MEMORANDUM

DATE: April 13, 2021

SUBJECT: PUDSP-20-005 – Falcon Meadows at Bent Grass (with EGP)
Third Submittal

Engineering Division

Sheet 7 of 12

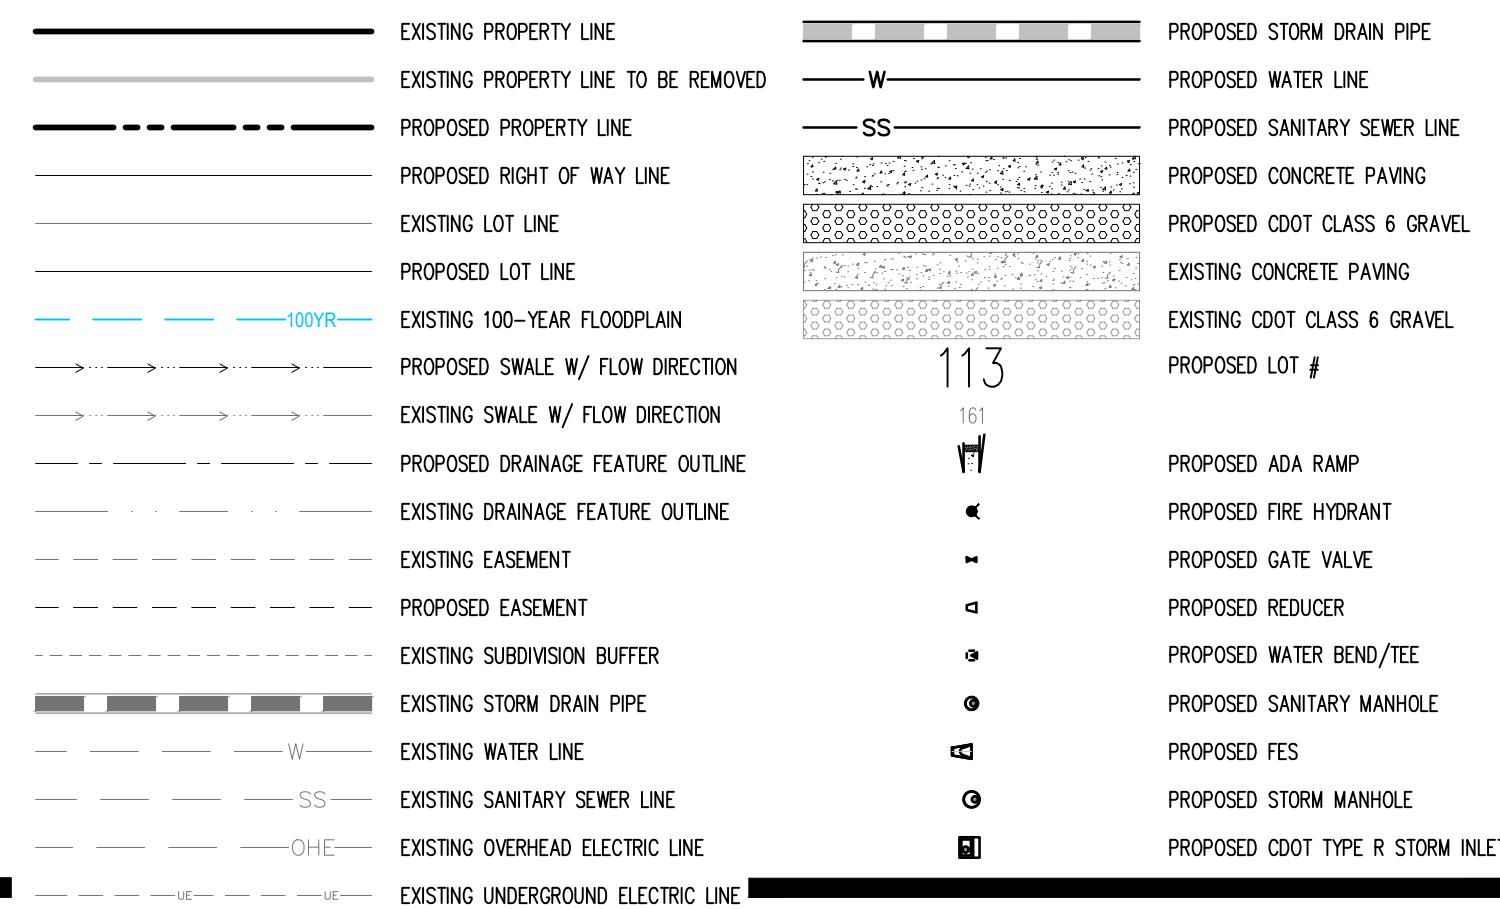
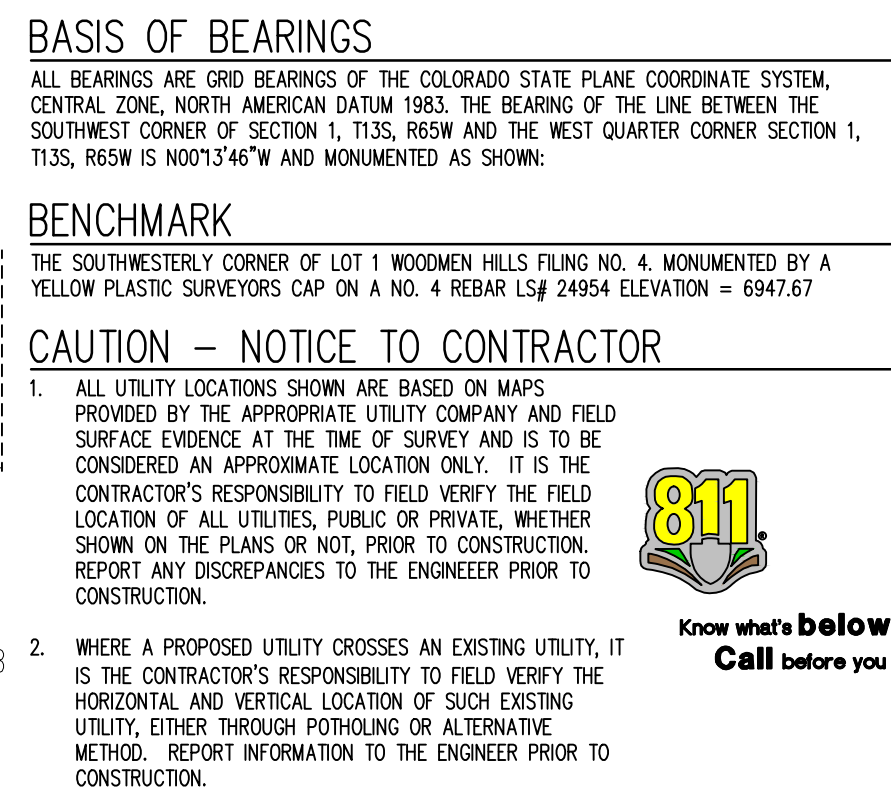
label the grade of the swales

slopes added for swales

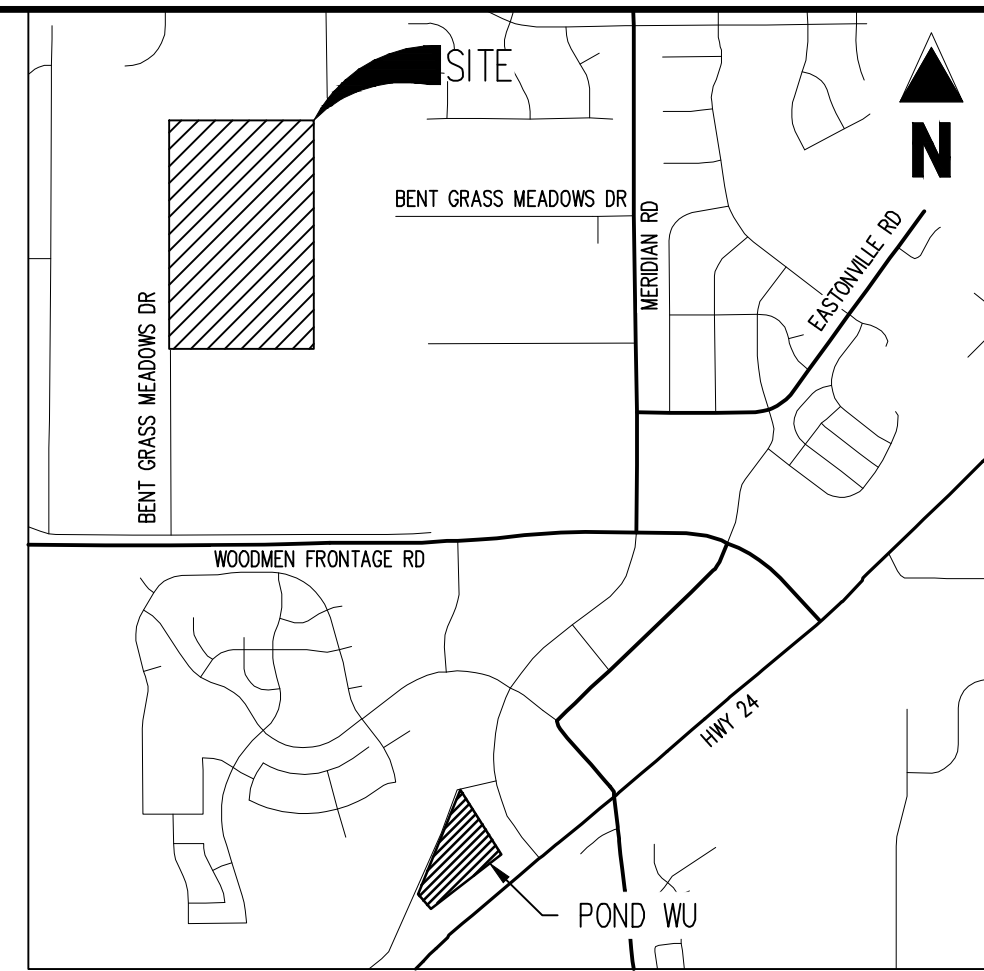
grate velocity is dangerous - larger box size is recommended

Box size upgraded. Final design is done as part of FDR.

PROPOSED DRAINAGE
MAP

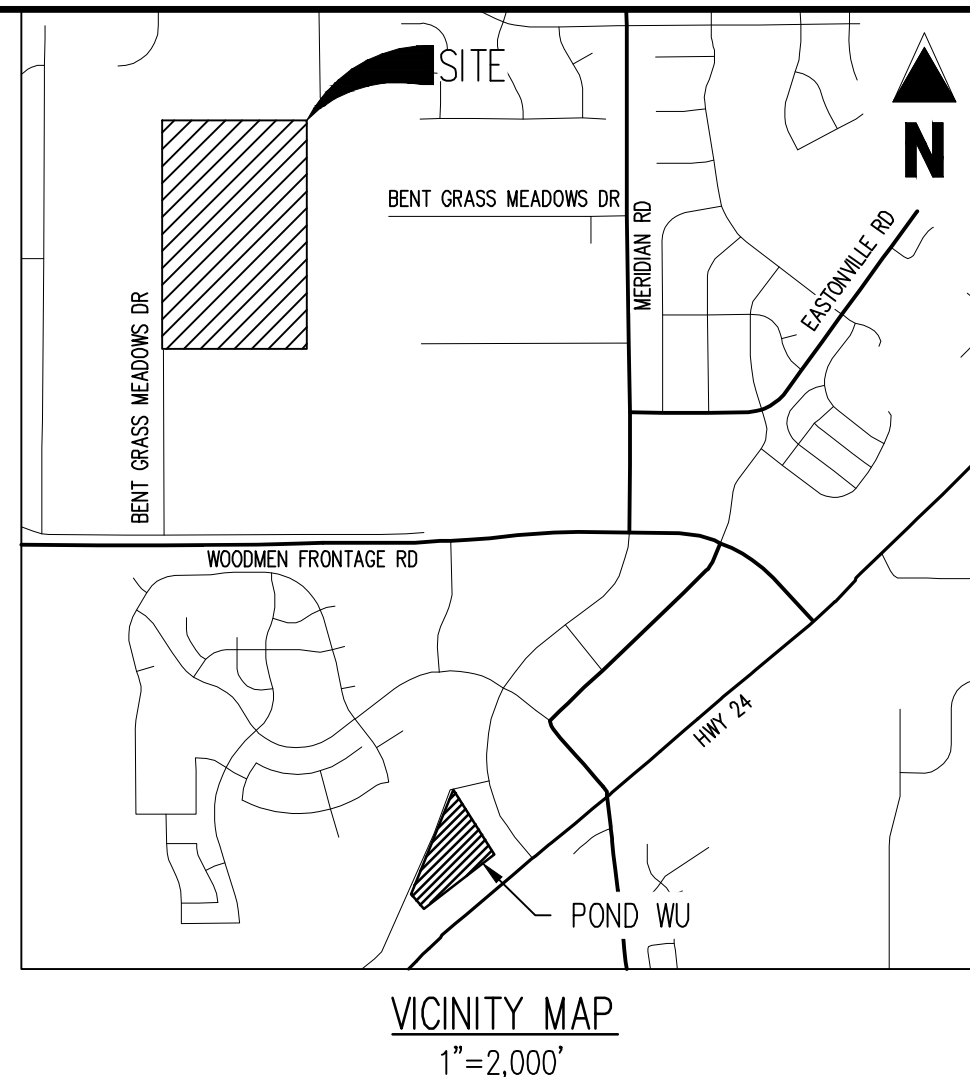
Basin line?
Basin updated

If this area can drain to DP24 it needs to be accommodated

Labels added

Calculations for overflow swale provided. Geometry of swale updated based on calcs.
